**Icing at the freezer fan at CBZF range**

**DESCRIPTION:**

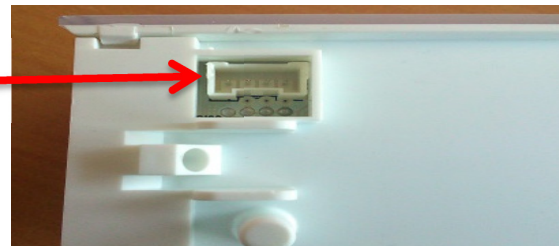
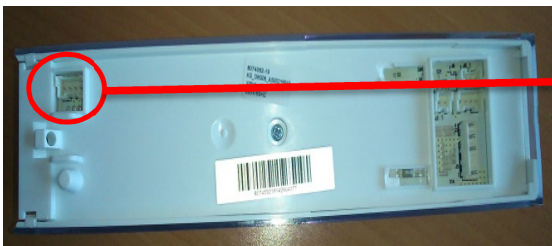
Appliance is noisy or the freezer isn't cooling well, due to the ice accumulation on front of the freezer fan.

The reprogramming of the PCB will solve the problem through the modification of defrost routine. For reprogramming service has to use the Sidekick equipment. For details please see the variants table.

1. Disconnect the power supply.
2. Detach the unit from the lamp unit holder.
3. Place the unit onto the ESD protection set.
4. Connect the unit to the AMI interface.
5. Start the reprogramming via Sidekick PC (for more details see the variants table).
6. Disconnect the unit.
7. Reattach the unit into the lamp unit holder.
8. Check all functions with service mode.
